## Product / Process Change Notification (PCN)

**PCN #:** PCN\_UtWPCC\_20200101

**Affected Series:** 760308103206

For the purpose of a datasheet information enlargement, Würth Elektronik will add some layout parameters including tolerances for the article 760308103206 and will correct the outer dimensions of the product.

**Before change**

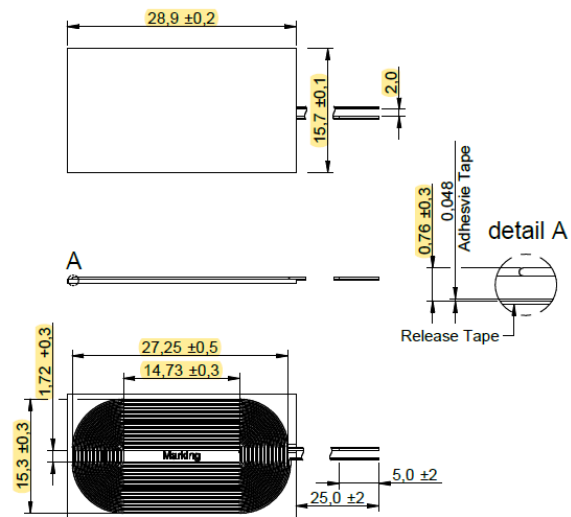
The datasheet of the article 760308103206 will be changed in the following way.
